Mulga Downs Iron Ore Mine – Assessment No. 2326 – Environmental Review Document – Response to Submissions

Table 1 Comments From EPA Services

FIGURE 8.15 Map 2 of 4

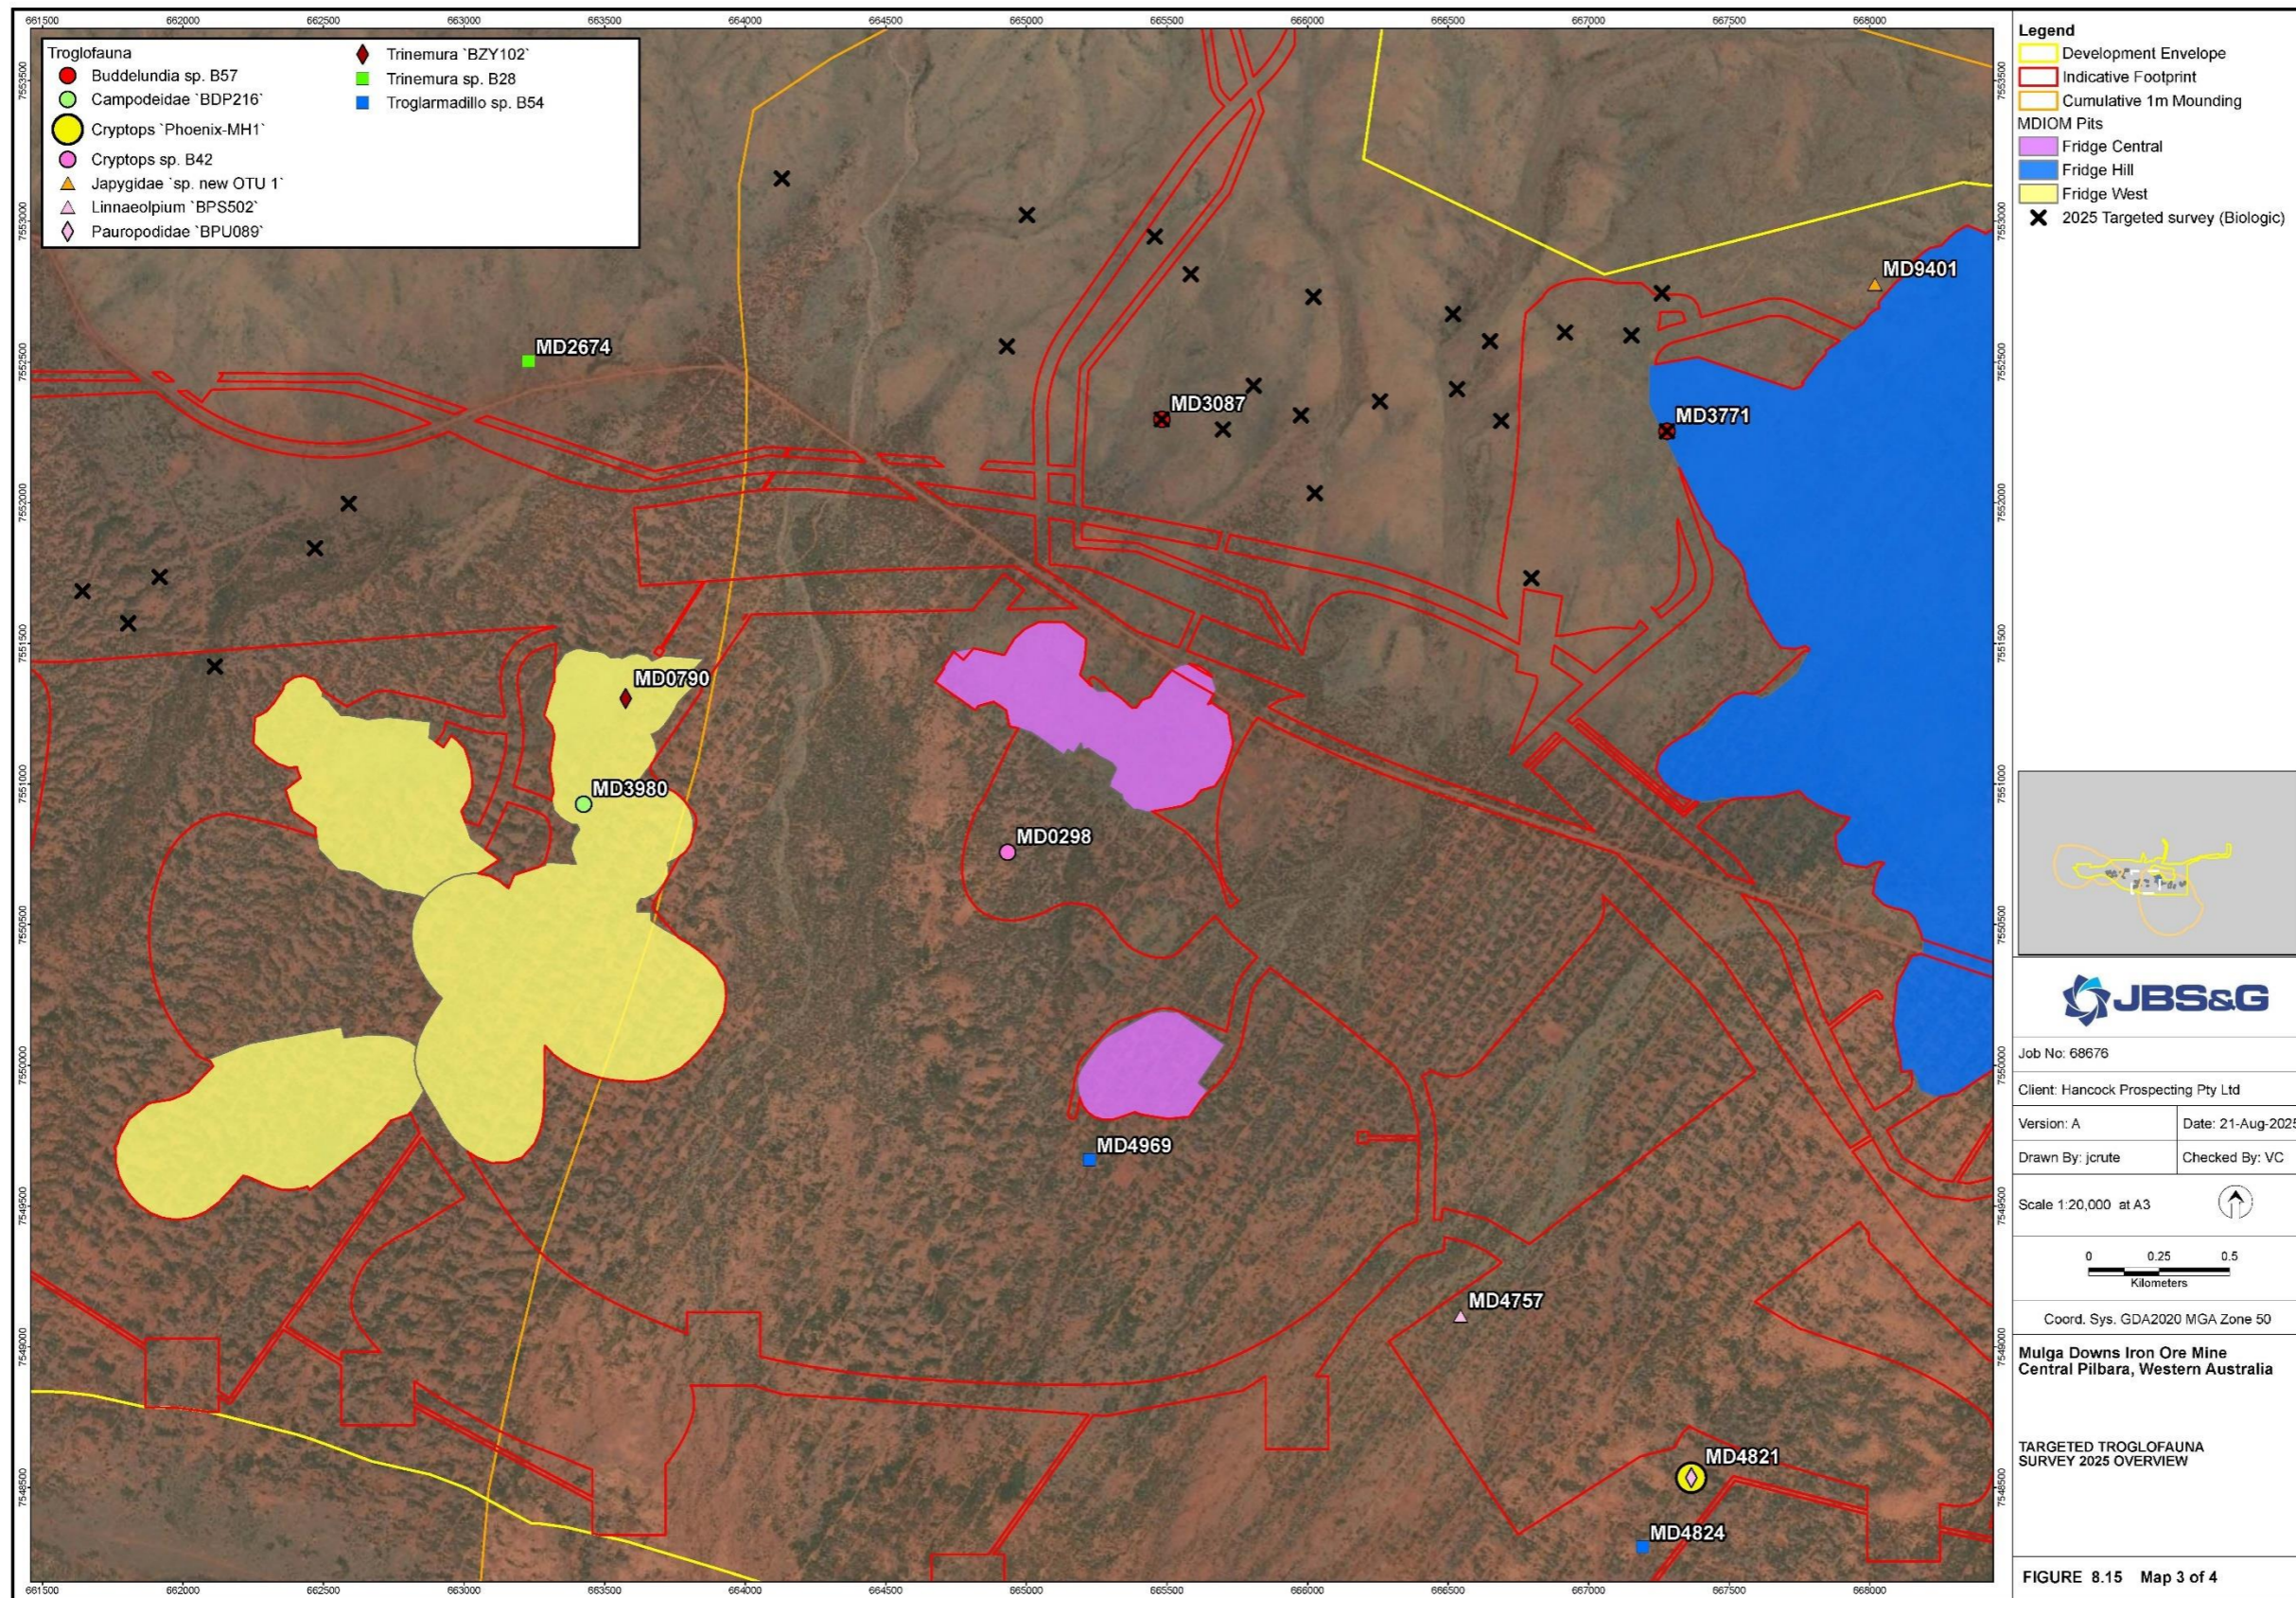
20. Some taxa identifications in the ERD are inconsistent. For example, Palpigradi ‘MH1’ and Palpigradi sp. B18 are listed as separate taxa in Table 8-6 but use the same symbol in Figure 8.15. This should be clarified, and the distributions and risk rankings revised, as appropriate.

FIGURE 7.29

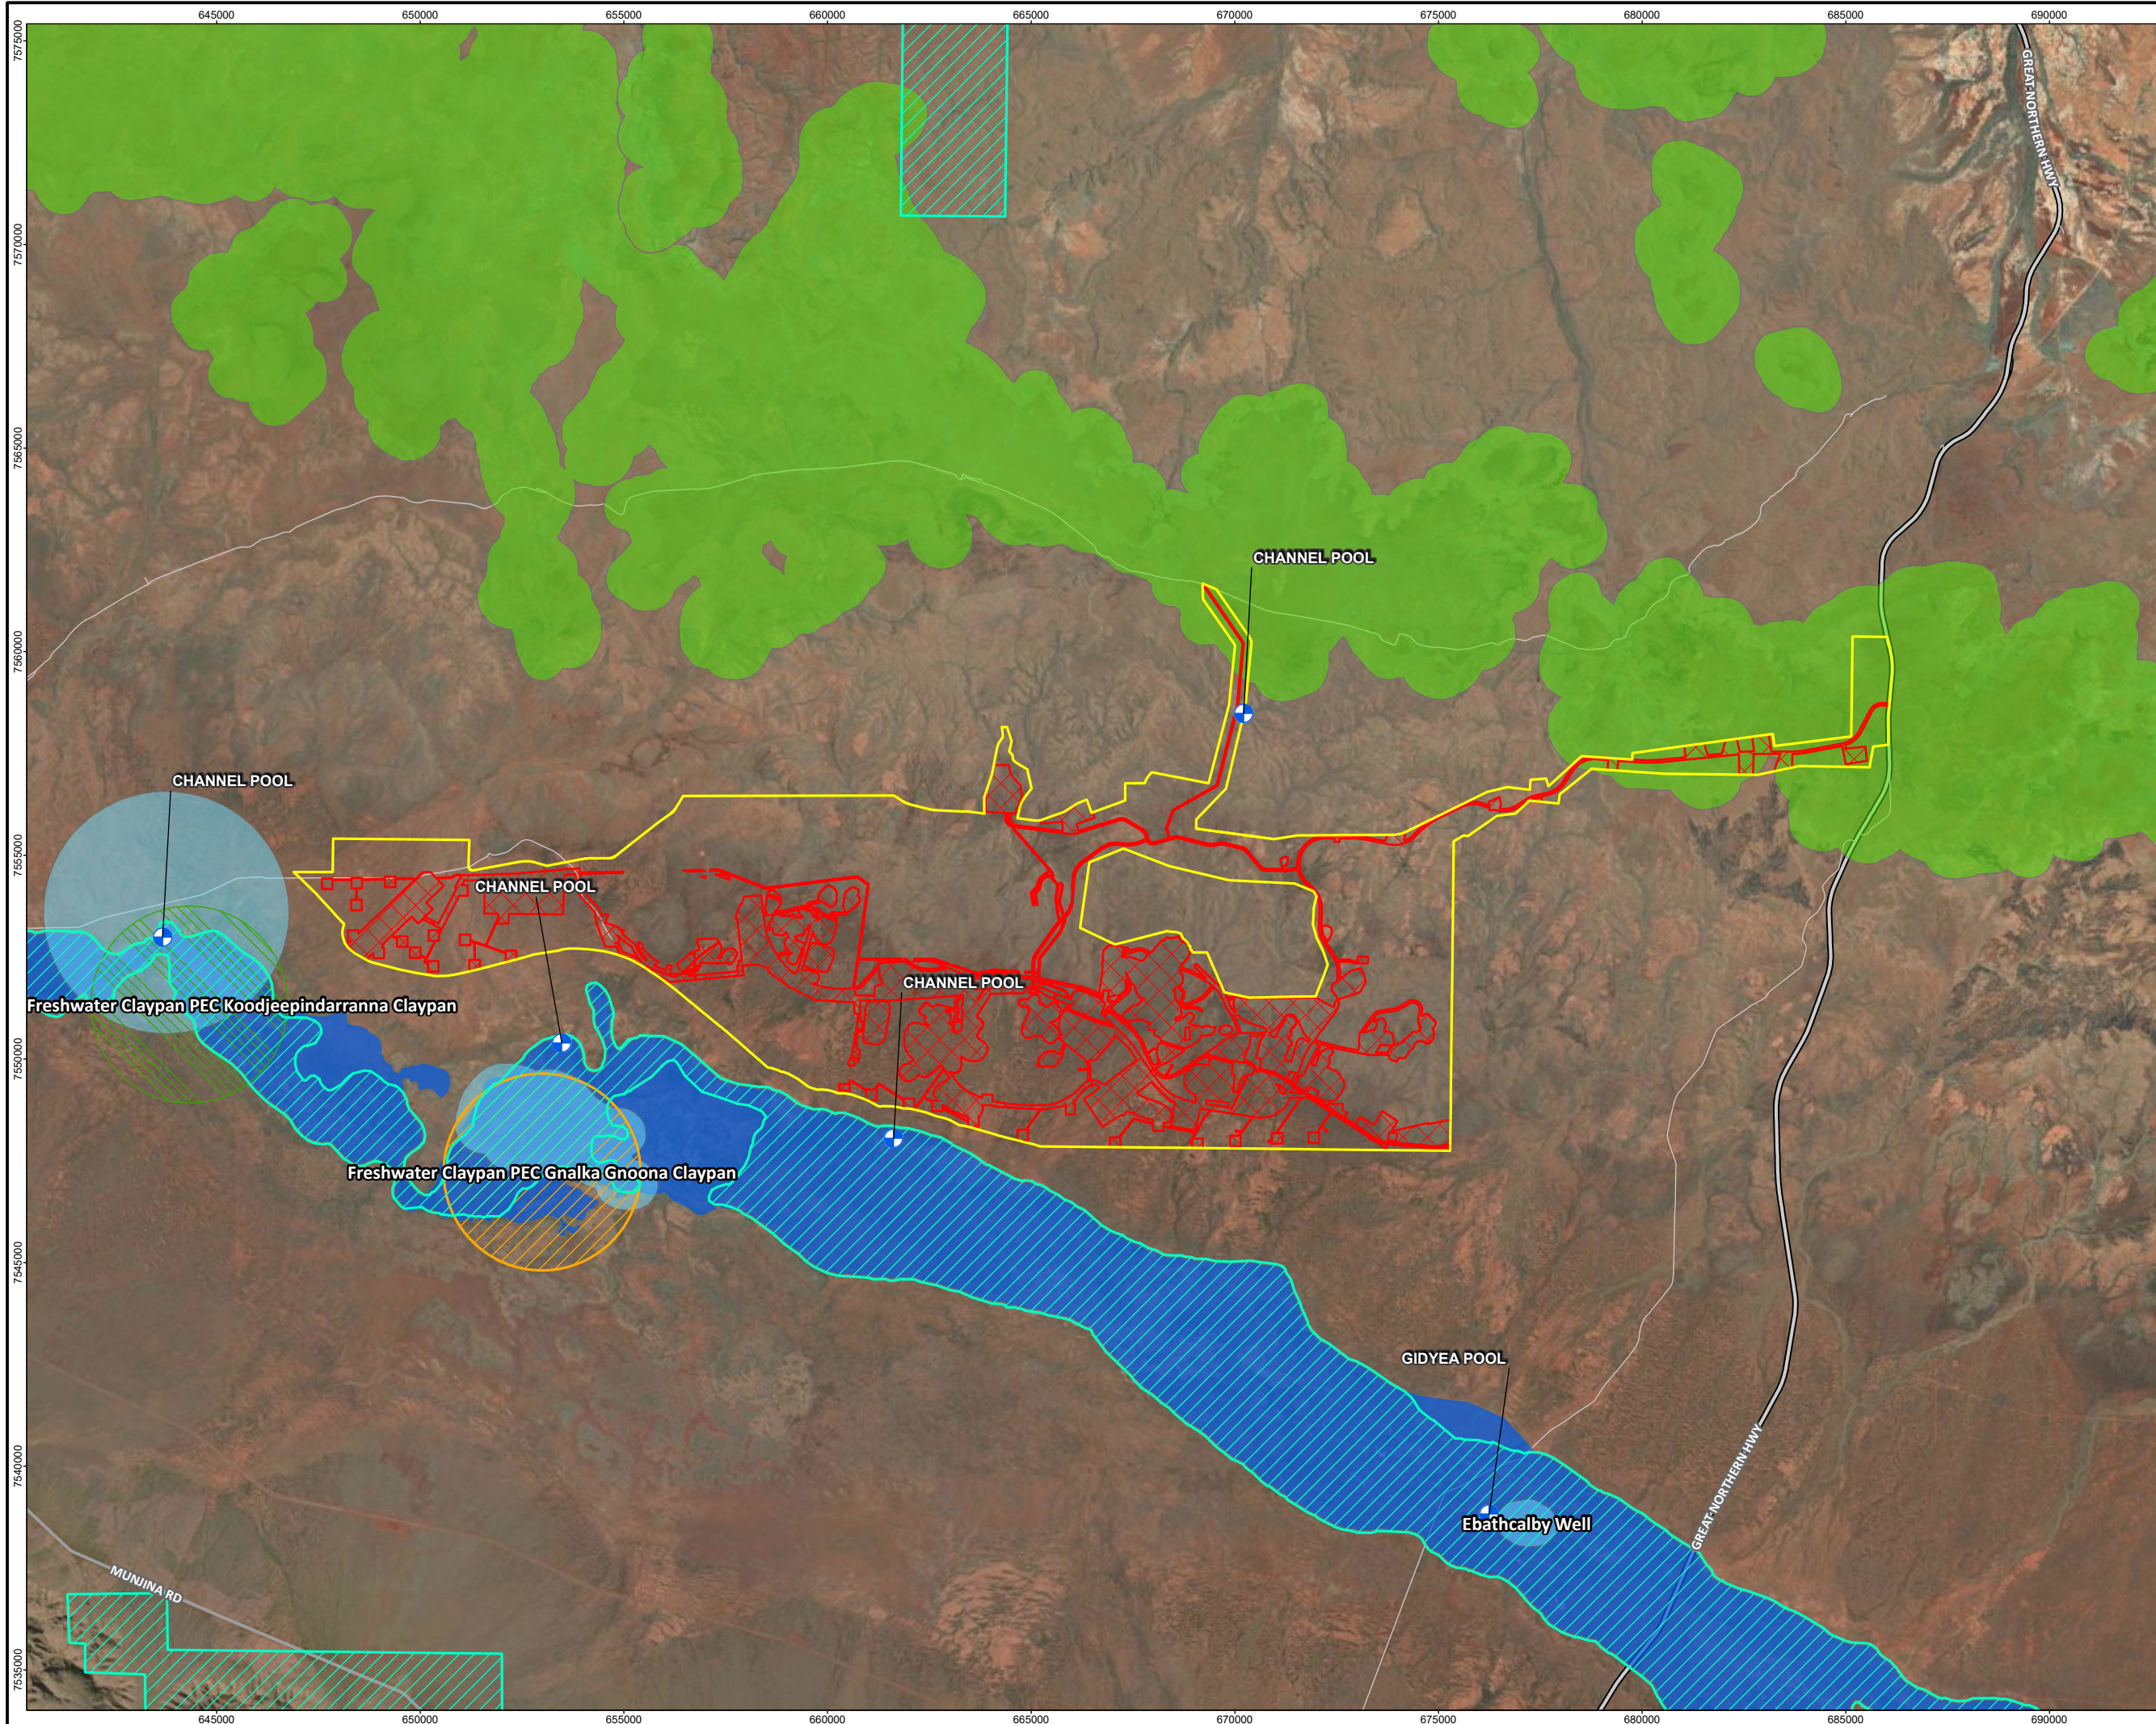
16. Section 7.3.7.2 of the ERD describes four surface water fed pools as local receptors. However, Figure 7-29 identifies 5. Clarity should be provided on the characterisation and ecological values of this additional pool, and any potential direct or indirect impacts.

"Section 7.3.7.2 of the ERD describes four surface water fed pools as local receptors. However, Figure 7-29 identifies 5. Clarity should be provided on the characterisation and ecological values of this additional pool, and any potential direct or indirect impacts."

The ERD notes that “Several small, surface water fed channel pools that hold water for a period of time following runoff events, in the Fortescue Valley, south of the Development Envelope occur.” The ERD lists four examples of channel pools with the introductory text “These pools include (but are not limited to):”. The four pools which are listed are all located downstream (south) of the mining area consistent with the introductory paragraph. The fifth pool, which is shown in Figure 7-29, is located on the northern side of the Development Envelope.

The ERD notes that "Several small, surface water fed channel pools that hold water for a period of time following runoff events, in the Fortescue Valley, south of the Development Envelope occur." The ERD lists four examples of channel pools with the introductory text "These pools include (but are not limited to)". The four pools which are listed are all located downstream (south) of the mining area consistent with the introductory paragraph. The fifth pool, which is shown in Figure 7-29, is located on the northern side of the Development Envelope.
